SUBJECT: Focused Early Action Corrective Measures Study/Feasibility Study in Support of Beneficial Reuse of Select Coal Ash and Coal Fines at the A-Area Ash Pile (788-A), A-Area Coal Pile Runoff Basin (788-3A), F-Area Ash Landfill (288-F), H-Area Ash Basin (288-H), K-Area Ash Basin (188-K), and L-Area Ash Basin (188-L) Operable Units (SRNS-RP-2024-00222, Revision 1, May 2025) (Redline Pages) and Savannah River Site's Responses to the Regulatory Comments on the Revision 0 Document, SEMS Numbers: 61, 62, 88, 90, & 91

1. SRS Responses to the U.S. Environmental Protection Agency's Comments on the Focused Early Action Corrective Measures Study/Feasibility Study in Support of Beneficial Reuse of Select Coal Ash and Coal Fines at the A-Area Ash Pile (788-A), A-Area Coal Pile Runoff Basin (788-3A), F-Area Ash Landfill (288-F), H-Area Ash Basin (288-H), K-Area Ash Basin (188-K), and L-Area Ash Basin (188-L) Operable Units (SRNS-RP-2024-00222, Revision 0, October 2024) SEMS Numbers: 61, 62, 88, 90, & 91

2. SRS Responses to the South Carolina Department of Environmental Services' Comments on the Focused Early Action Corrective Measures Study/Feasibility Study in Support of Beneficial Reuse

Figure 3. A-Area Ash Pile Topography and Ash Observation Transects

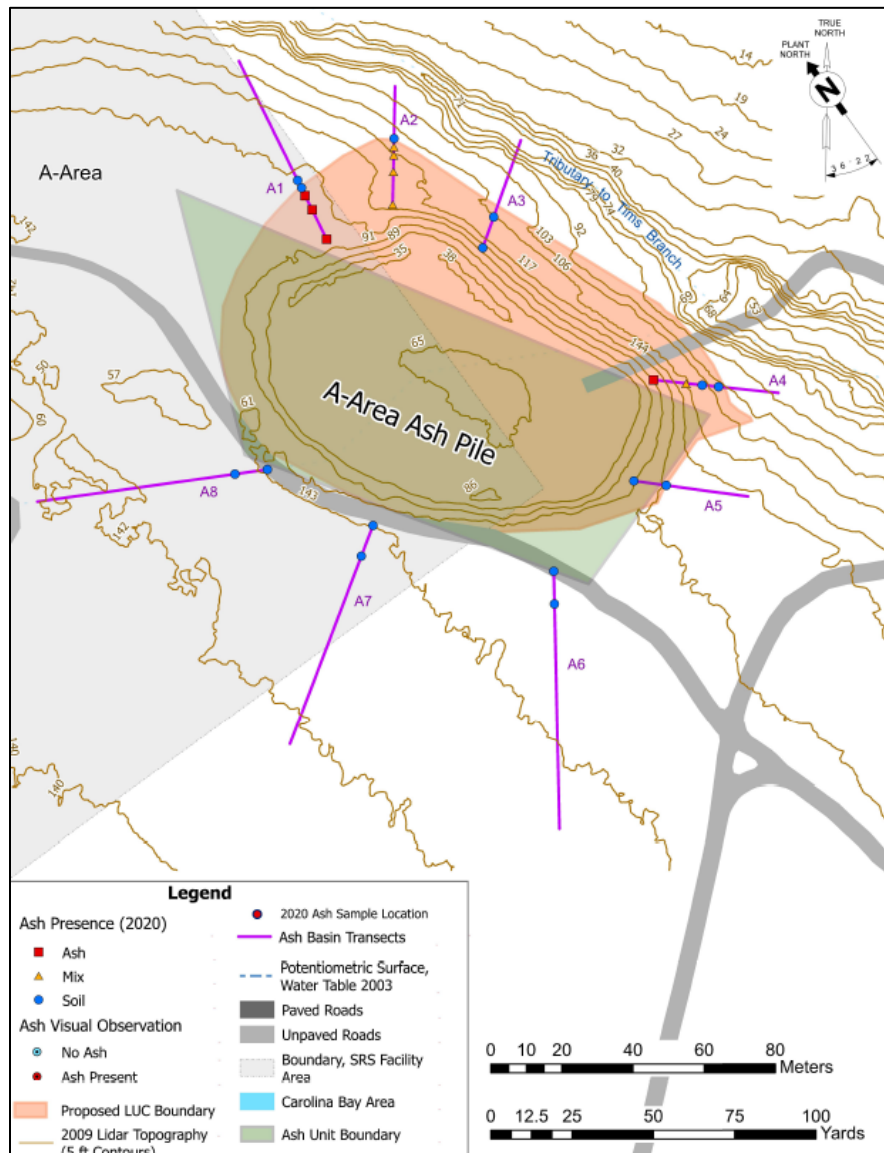
1. The CMS/FS does not clearly describe how the extent of the coal ash was determined at each Operable Unit (OU). The symbols designating where ash, soil, or a mixture of soil and ash were found in the transects shown on Figures 3 through 8 are not always consistent with the extent of ash shown. For example, soil markers are shown within the ash extent to the northeast on Figure 3 (A-Area Ash Pile Topography and Ash Observation Transects); however, the ash extent does not include observed ash present in the southeastern transect on Figure 7 (K-Area Ash Basin OU Topography and Ash Observation Transects). In addition, it does not appear that the extent of ash was completely defined, as some of the transects do not have an observation of soil to bound the extent (e.g., Figure 5, the northwestern quadrant of the F-Area Ash Landfill, and Figure 8 to the south at the L-Area Ash Basin) or there is an absence of transects (e.g., Figure 6, to the north at the H-Area Ash Basin). Further, it is unclear how the depths of ash as specified in Section 1.2.2 (Nature and Extent of Contamination) were determined for each OU as only surface samples were collected. It is also noted that Format F-4 in the *Environmental Compliance and Area Completion Projects Regulatory Document Handbook*, dated June 2023 (the EC&ACP Regulatory Document Handbook) indicates that schematic cross sections should be provided. *Please revise the CMS/FS to describe how the lateral and vertical extent of the ash at each OU was determined and correct or explain any discrepancies in the symbols used on Figures 3 through 8. Also, revise the CMS/FS to include cross sections of the OUs as indicated in the EC&ACP Regulatory Document Handbook.*

Figure 3 and Figures 5-8 were revised and are included with these comment responses. Additional information in support of the revised figures include the following:

- In Figure 3, the surface transect data did find soil within the footprint of ash that was already indicated by the LiDAR data.
- The transect described for the FAL (Figure 5) ended due to a road impedence (northwestern quadrant of FAL), and the recorded description of transect F19 (on revised figure) stated that thick vegetation prevented access to that area beyond the initial ash location.
- For Figure 6 for the HAB, ash to the north is bound by LiDAR data and by the road. The southeastern transect (H3) does not have a terminal soil marker, but the transect data recorded the extent of ash is 520 ft from origin.
- For Figure 7 (KAB), the visual observations indicated by the light blue dots on the southwestern boundary were used for extent on this boundary. Also, the northern transect extent of ash was estimated at 52 ft from the origin based on the transect data recorded.

Revised Preliminary CSMs (Specific Comment #13)

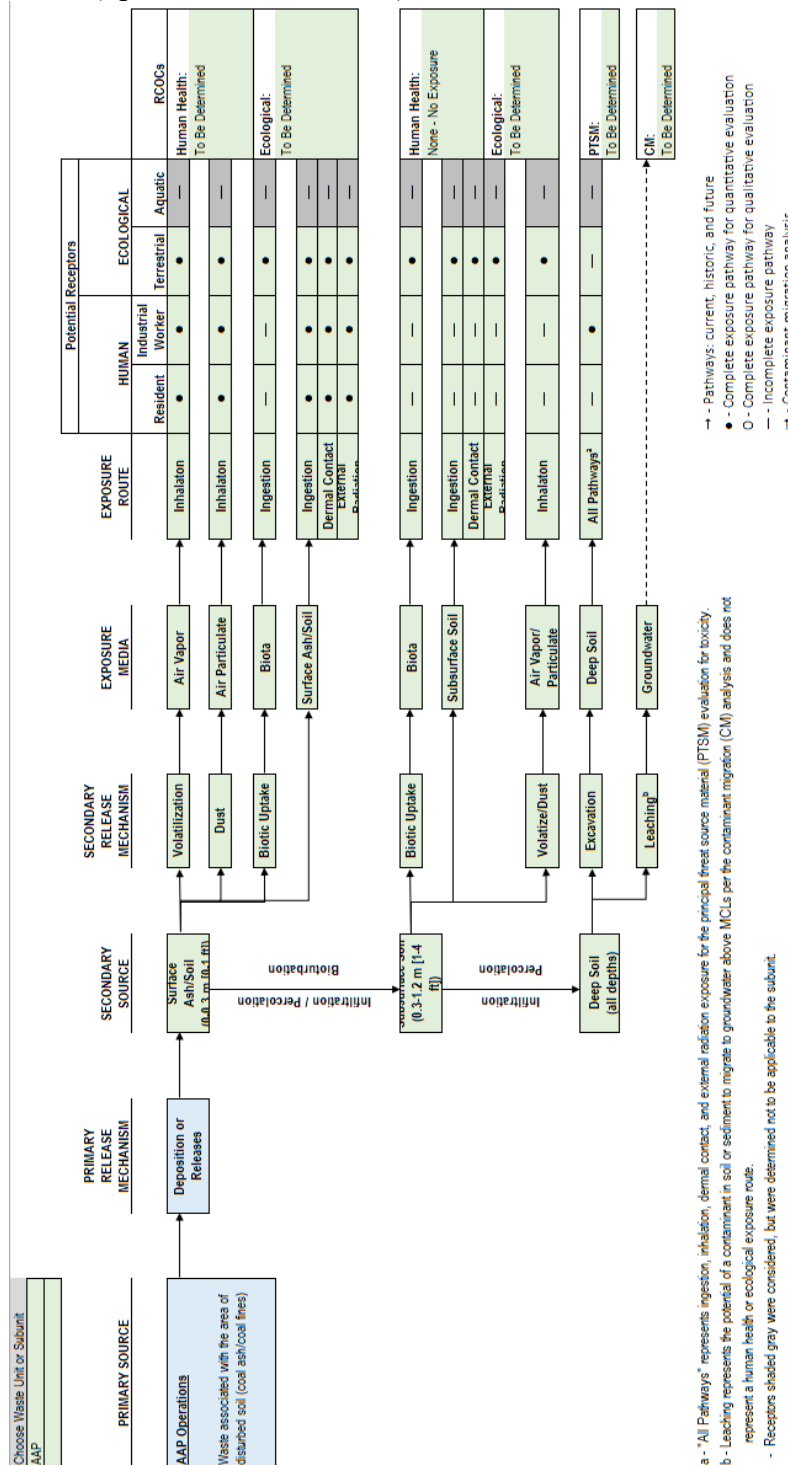
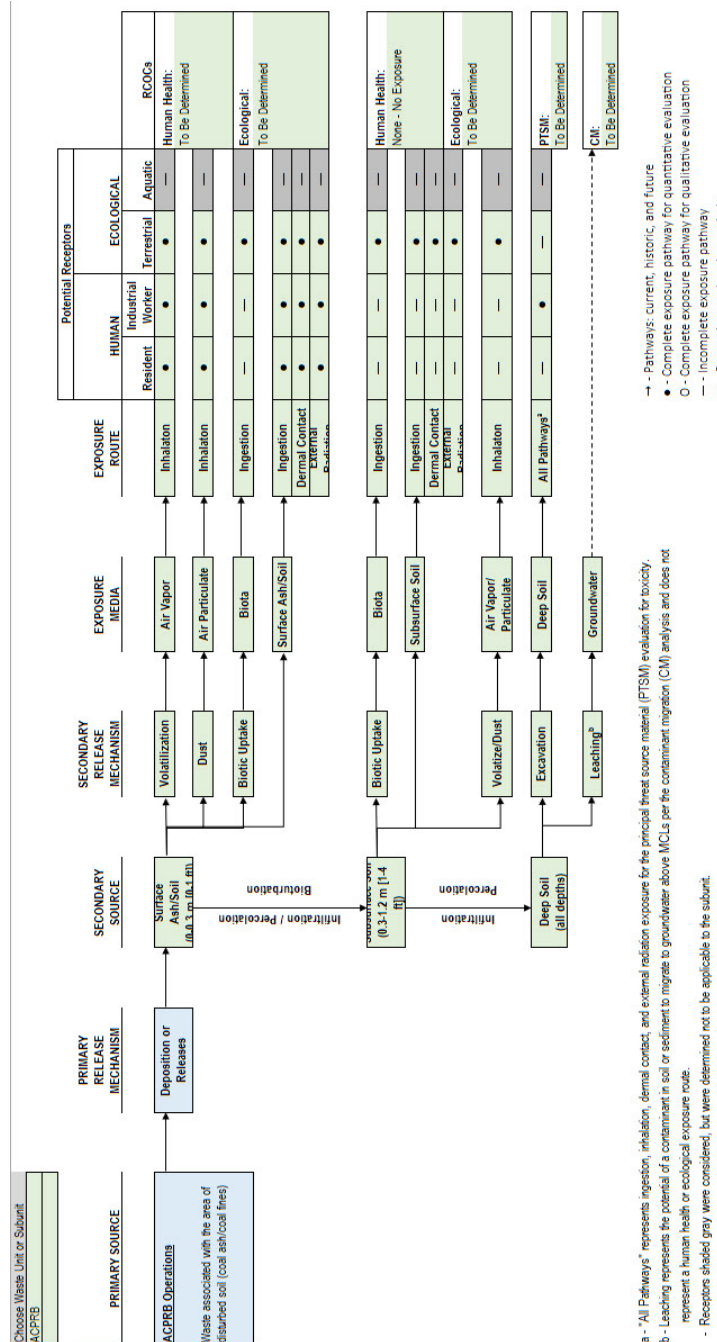
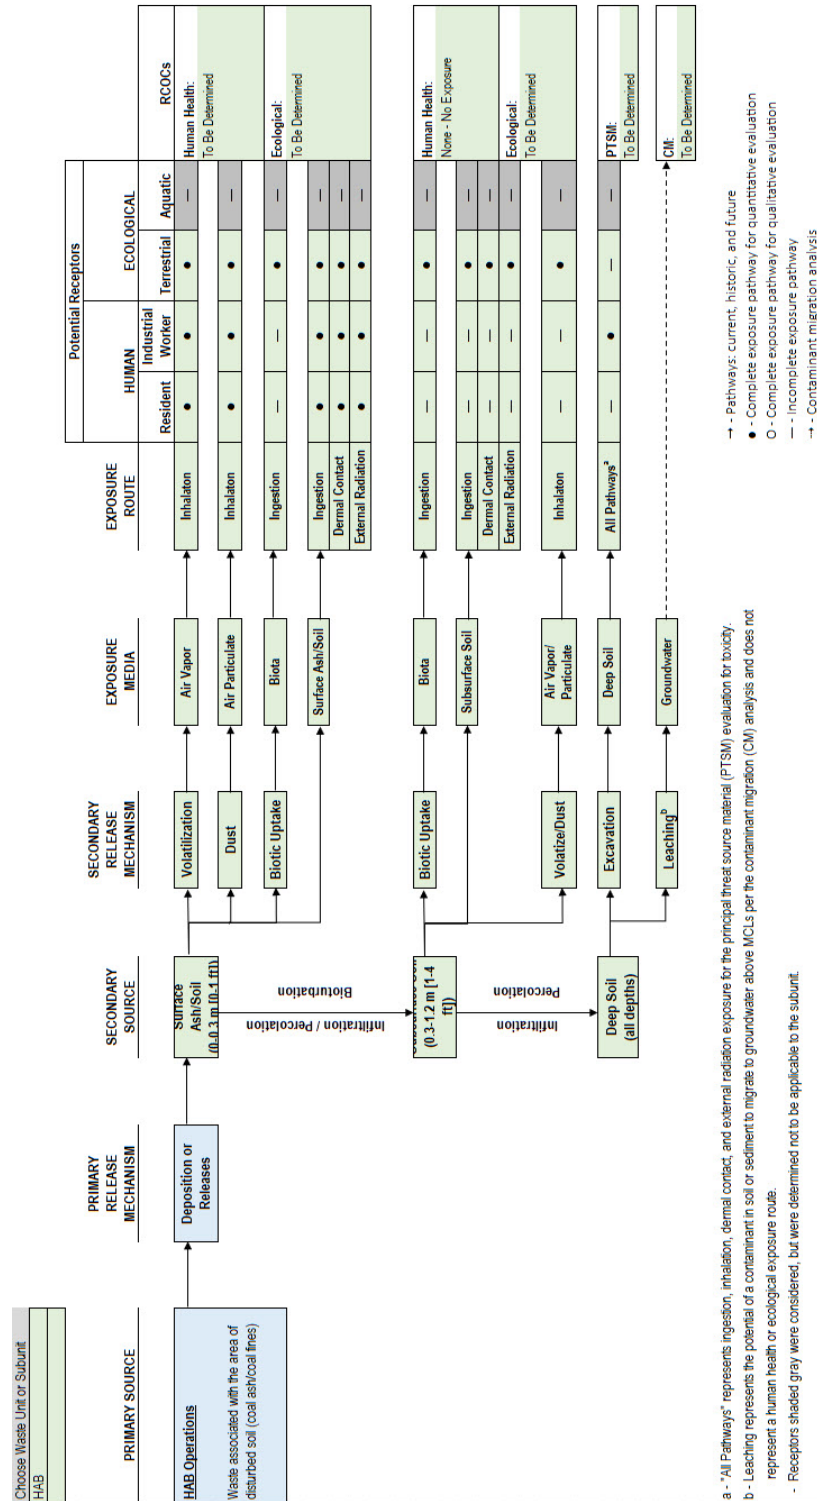
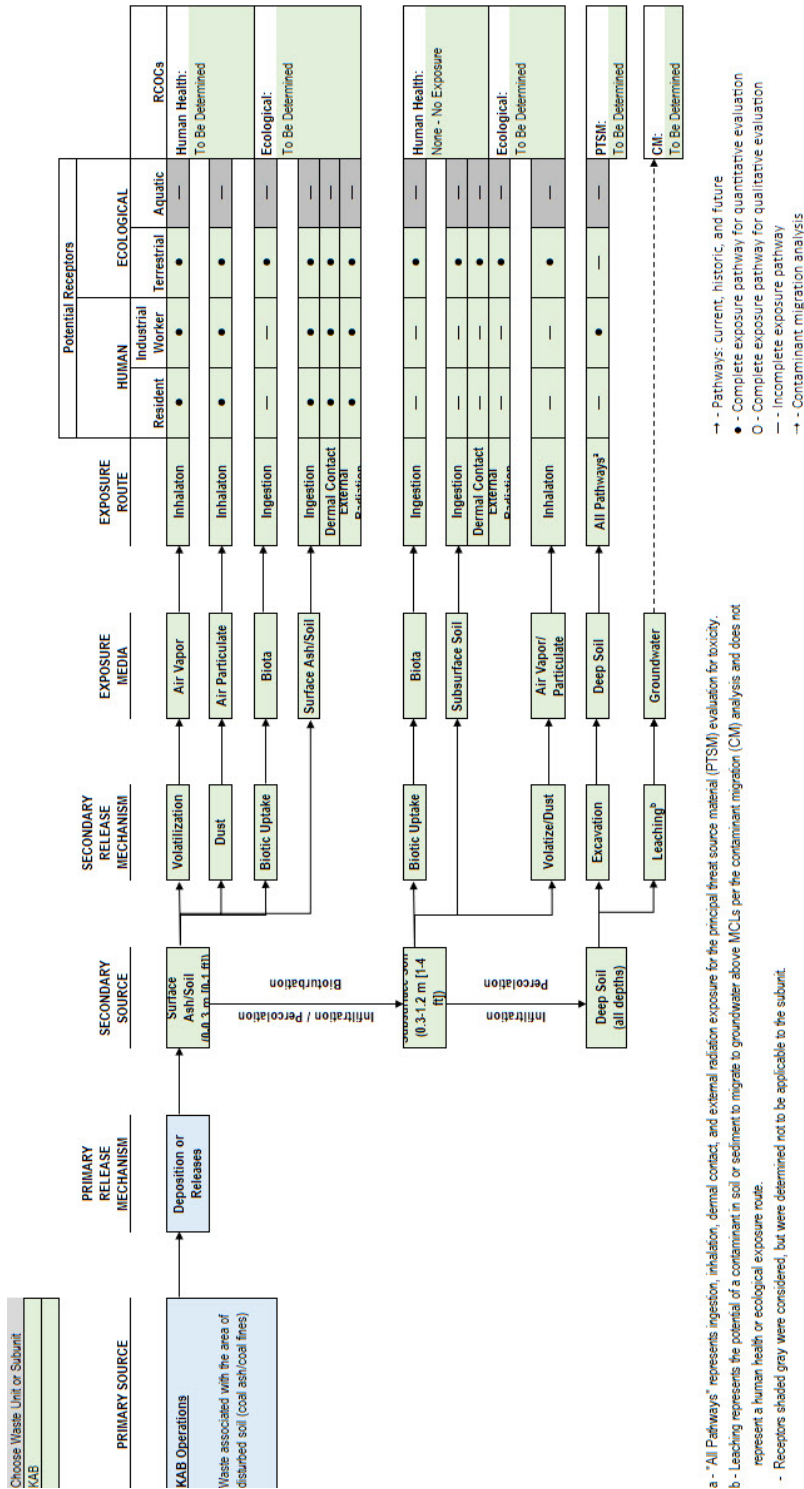
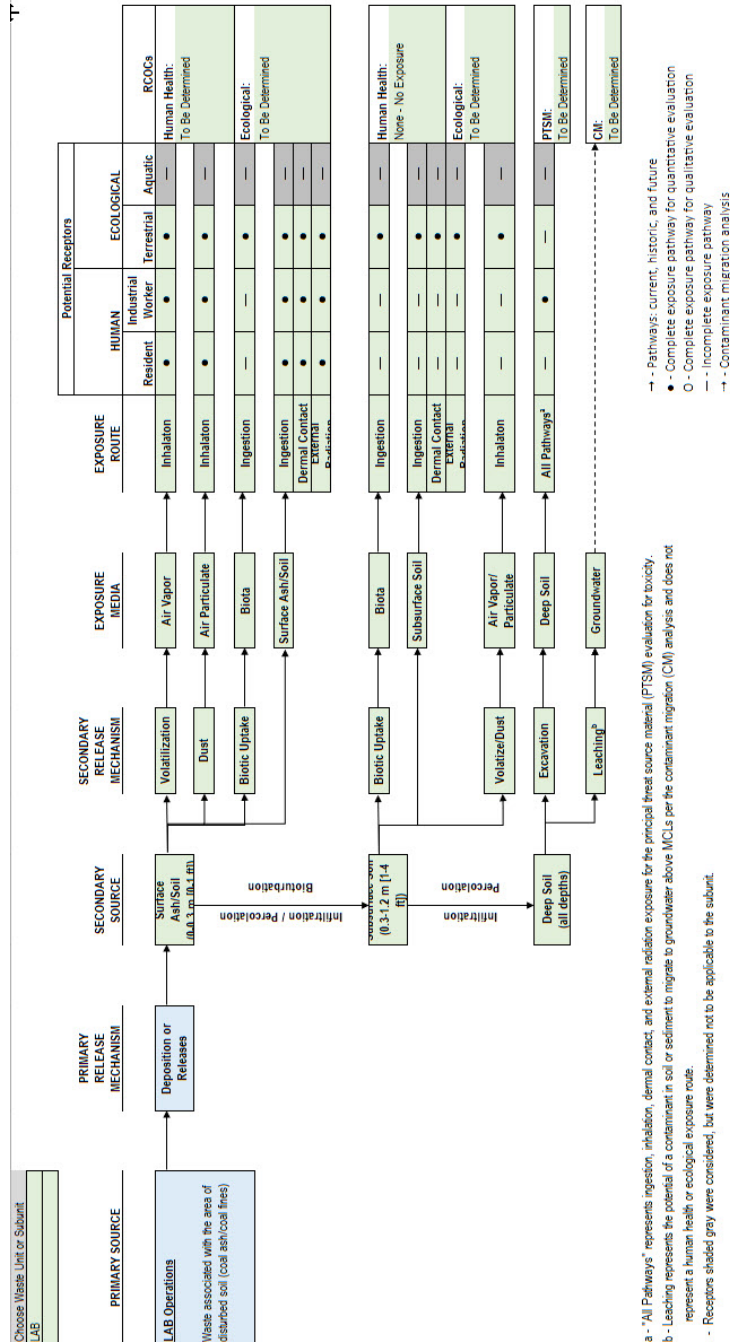
13. **Appendix D, Ecological Risk Assessment, Section D-2.3.4, AAP and ACPRB OU – Soil Medium, Page D-31 of D-112:** It is uncertain why sediment and surface water results are included in this section. Based on the CSMs, there are no complete aquatic exposure pathways on the site. Section D-1.3, Habitats/Receptors/Preliminary Assessment and Measurement Endpoints, mentions that there was marginal aquatic habitat present in this part of the site at one time, but it has become much less appreciable through secondary succession. *Please either revise this section by removing all discussions of risk results based on aquatic exposure pathways, or add a new symbol to the appropriate CSM, indicating that the aquatic exposure pathways were once considered complete but are not currently operating.*

The CSMs will be revised to shade the boxes for the aquatic receptor in gray. A footnote will be added to define the gray shaded boxes as, “indicates that the receptor and media scenarios were considered but are not applicable to the unit.”
